**CITY OF FOSTER CITY
FOSTER CITY COUNCIL CHAMBERS
620 FOSTER CITY BOULEVARD
FOSTER CITY, CALIFORNIA**

SUBJECT: LEVEE PROTECTION PLANNING AND IMPROVEMENTS PROJECT (CIP 301-657) INCLUDING: (1) CERTIFICATION OF THE FINAL ENVIRONMENTAL IMPACT REPORT AND ADOPTION OF A STATEMENT OF FINDINGS UNDER THE CALIFORNIA ENVIRONMENTAL QUALITY ACT, A STATEMENT OF OVERRIDING CONSIDERATIONS, AND A MITIGATION MONITORING AND REPORTING PROGRAM (EA-15-002); (2) APPROVE THE 2050 SLR PROJECT SCENARIO AND DIRECT STAFF TO FURTHER DEVELOP AND ANALYZE THE OPTION 4 2050 SLR AND FUTURE ADAPTATION STRATEGY DESIGN VARIATION BEFORE SUBMITTING TO REGULATORY AGENCIES FOR PROCESSING; AND (3) DIRECT STAFF TO PROCEED WITH THE 30-YEAR GENERAL OBLIGATION BOND ALTERNATIVE

Response to Comments Document

FIGURE 2 EXISTING LEVEE ELEVATION DEFICIENCIES FOR WAVE RUNUP

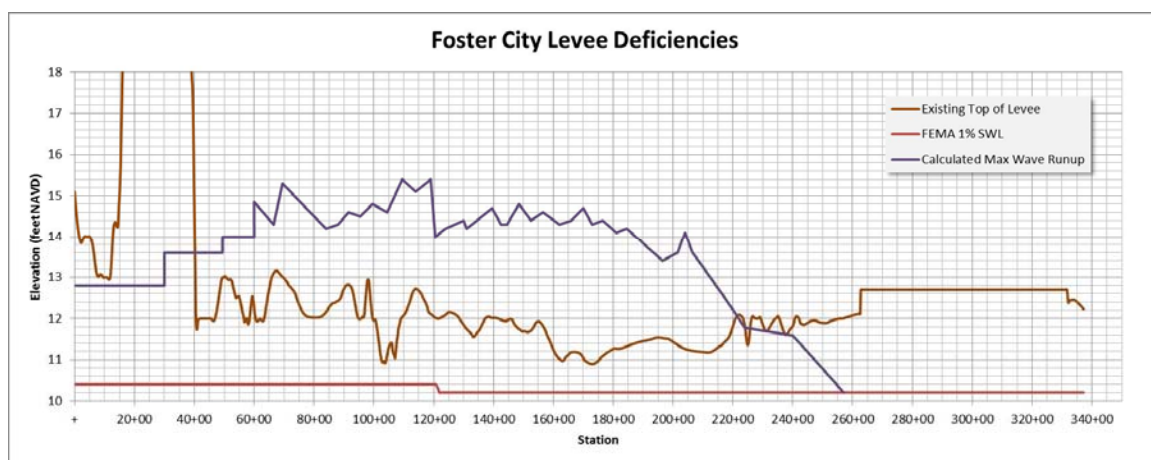
There is a 2.5-mile stretch of the existing levee system that is subject to overtopping, spanning from the high ground at Mariner’s Point on the west end to the shell bench on the east end near the mouth of Belmont Slough (Figure 2). This 2.5-mile stretch is broken into 10 sections, each with a similar average levee slope, and the break parameters and overtopping rates (in cubic feet per foot) are estimated for each section. Two methodologies have been chosen to estimate the mean rate of wave overtopping. The first, formulated by Owen (1980) and updated in the EurOtop overtopping manual, uses empirically derived coefficients for various structure slopes:

The 2.5-mile stretch of the existing levee system subject to wave overtopping is located between the high ground at Mariner's Point on the west end to the shell bench on the east end near the mouth of Belmont Slough (Figure 2 in response A1-2). This 2.5-mile stretch is broken into 10 sections, each with a similar average levee slope, and methodologies found in the literature are used to estimate overtopping rates (in cubic feet per foot) for each section and the volume of water spilling over the levees throughout the tide cycle is established based on the probability of wave overtopping for the given conditions.

FIGURE 5 OFFSHORE WIND EFFECT ON WAVE SETUP

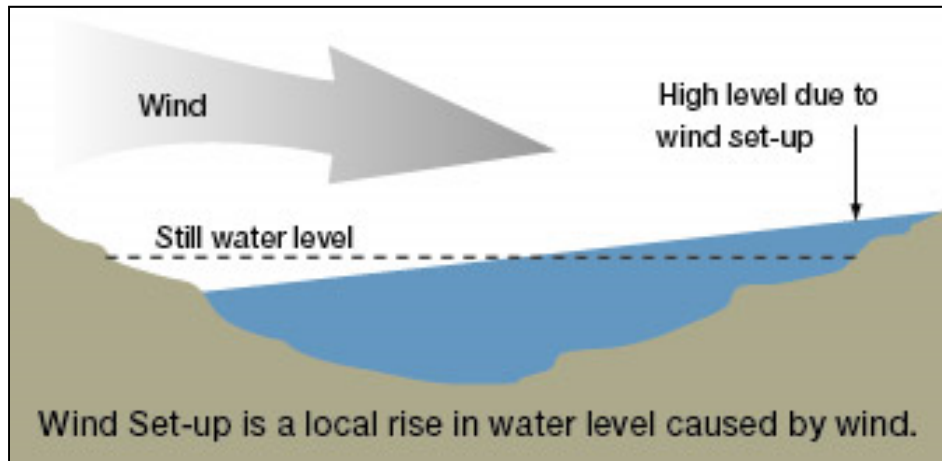
It is also noted that prevailing winds would also act to render insignificant the impact of increasing freeboard at the Foster City levee system. Generally wave overtopping at Foster City would only occur when waves are directed towards the City's levees with a prevailing southwesterly wind. This condition would generally result in wind-induced setup, or a local rise in water surface downwind and an associated drop in water surface upwind; that is on the levee side of the bay, and in this case specifically, Alameda County. Conversely Alameda County should be more concerned about the impact of wind-driven waves when the prevailing wind is in the northeasterly direction, generally perpendicular to its shores; when at Foster City this prevailing wind is offshore and levee improvements to protect against wave runup are not in play. Figure 5 illustrates this effect.

As demonstrated above in Figure 5, the project would have only a negligible impact on water levels around the bay, far less than the 0.1-foot water level increase suggested by

FIGURE 8 "BAYSIDE LEVEE" RENDERING PREVIOUSLY PROVIDED BY LAW OFFICES OF MARK C. WATSON

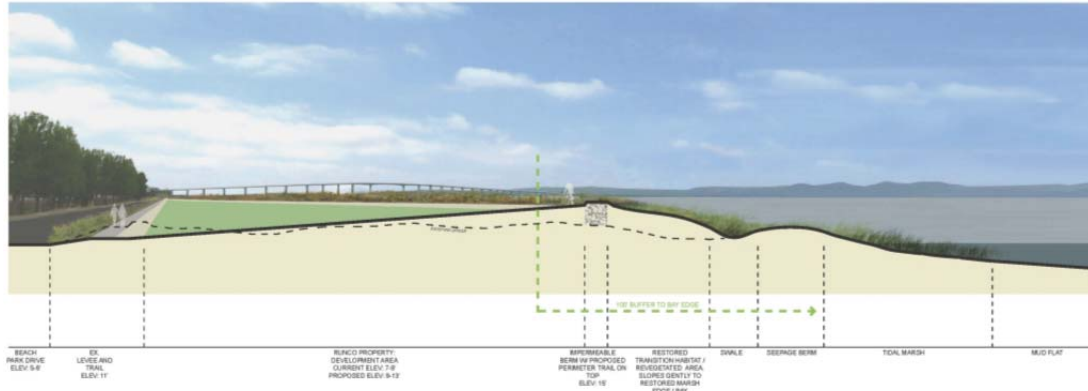
Response B1-9. The comment refers to mock-up renderings submitted by the Offices of Mark C. Watson, referred to as the "Bayside Levee" suggested by the commenter and included as Figure 8. These renderings appear similar to the levee realignment Mr. Runco

The alternative advocated by the commenter is not to be confused with a “horizontal levee” with hundreds of feet of offshore fill. A true horizontal levee that would effectively dissipate wave energy needs to typically be laid back with 30:1 side slopes as measured horizontal to vertical. Such a levee configuration could extend a significant distance into San Francisco Bay at the location shown on conceptual plans (shown in Figure 8) for this requested alternative. The alternative suggested by the commenter is rather a relatively traditional levee system, but with restored habitat on the offshore slope. Since an offshore breakwater is not shown, the levee elevation still needs to be sufficiently high to provide the requisite FEMA freeboard against wave overtopping.

The alignment of the “Impermeable Berm with Proposed Perimeter Trail” is not sufficiently precise to allow for a meaningful impact analysis. Figure 8 shows the location of the berm as apparently 100 feet away from the “bay edge,” with that edge defined as “tidal marsh,” but that edge is not defined in terms of tidal elevation. The requisite elevation of the “Bayside Levee” alignment would, therefore, need to be verified to determine its viability for wave protection since it is much closer to the shoreline than the existing levee alignment, which has been evaluated by the City in terms of required wave protection elevations.

Note however, that the City’s conclusion that the Bayside Levee alternative is not a feasible project alternative under CEQA, does not preclude the Bayside Levee alternative from being incorporated into or approved as part of Mr. Runco’s separate development project application which will require its own separate environmental review under CEQA and will have its own project objectives.

Figure 9. Model for 100-year Wave Overtopping of Existing Levees

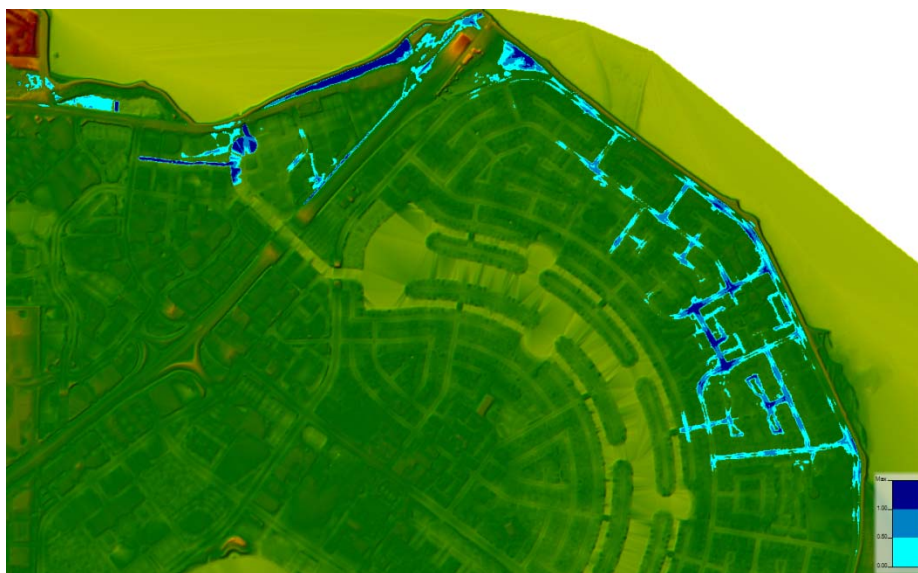
Figure 9 shows the results of a two-dimensional flow model that routes this volume of water from the perimeter levee system into the Central Lagoon; again, assuming that none of the levee system fails due to this overtopping. Although the levees are not designed with erosion protection for such overflow, it is noted that maximum overflow velocity is on the order of 2 to 3 feet per second, and while not acceptable for FEMA accreditation, it is relatively likely that the majority of the levee system would remain intact.

Figure 9 shows that bay waters are able to flow into the storm drain system and lagoon without excessively deep water spread over private properties. At its normal winter operating “storm level” of 1.0 foot NAVD, the surface area of the lagoon is 230 acres. The 23.3 acre-feet of water overtopping the levees would add about 1.0 foot of water to the lagoon. Without any pumping, the increase in water level would match the lagoon’s normal summer level of 2.0 foot NAVD. Thus the City’s existing facilities can accommodate the 100-year spill event under existing conditions, even without warning or prior evacuation of the lagoon; and there is no need to raise the pumping facility or equipment therein.

Raising the levee as part of the project would greatly reduce the risk of wave overtopping and bay overflow into Foster City as shown in Figure 9, particularly since additional freeboard is provided relative to existing conditions. Since there would be no change to lagoon operations and the pumping facility is already protected against flooding, the pumps do not need to be raised in the future. Possible future sea level rise could result in higher levels in the bay that must be pumped against, but this can be adapted to by increasing individual pump horsepower within the existing facility.
